Access Compliance Report

Public Rights-of-Way

(Curb Ramps)

Intersection ID: 49138	Main Street: CLARKE RIDGE CT	Cross Street: AMBER LEIGH WAY DR	Location: SW
ADA ID: 68BDBE712F27	Ramp Type: PerpDiag	Initial Pass/Fail: Fail	Overall Compliance: No
Severity Score: 10			
Codes/Mitigation Info/Possible Solution		Field Measurements/Component Compliance

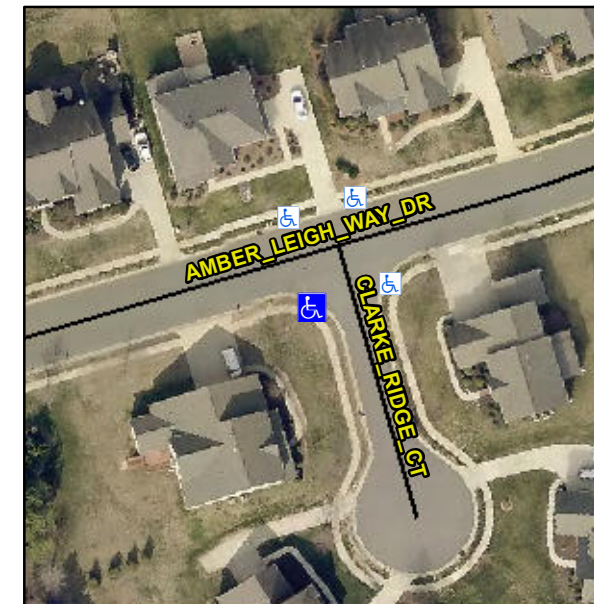
Not Found, R304.5.1, R304.5.3

Compliance	Description	Data	Compliance	Description	Data
N/A	Ramp Length (in)	47.0	Yes	Ramp Slope (%)	5.9
No	Ramp Width (in)	46.5	No	Ramp XSlope (%)	4.7
N/A	Flare Type LT	N/A	N/A	Flare Type RT	N/A
N/A	Flare Slope LT (%)	N/A	N/A	Flare Slope RT (%)	N/A
N/A	Flare Traversable LT?	N/A	N/A	Flare Traversable RT?	N/A
N/A	Landing Length (in)	N/A	N/A	DWS Provided?	N/A
N/A	Landing Width (in)	N/A	N/A	DWS Contrast?	N/A
N/A	Landing Slope (%)	N/A	N/A	DWS Length (in)	N/A
N/A	Landing X Slope (%)	N/A	N/A	DWS Full Width?	N/A
N/A	Landing Curb? (Y/N)	N/A	N/A	DWS Offset (in)	N/A
N/A	Shared Landing?	N/A			
N/A	Gutter Ponding?	N/A	N/A	Gutter Slope (%)	N/A
N/A	Gutter Lip Ht (in)	N/A	N/A	Gutter X Slope (%)	N/A
N/A	Painted X Walk1?	No	N/A	Painted X Walk2?	No
	X Walk 1 Direction	To E		X Walk 2 Direction	To N
N/A	X Walk 1 Width (in)	N/A	N/A	X Walk 2 Width (in)	N/A
	X Walk 1 Slope (%)	2.5		X Walk 2 Slope (%)	6.2
	X Walk 1 X Slope (%)	4.9		X Walk 2 X Slope (%)	1.7

Remove & Replace Curb Ramp With Two New Directional Ramps or Equivalent.
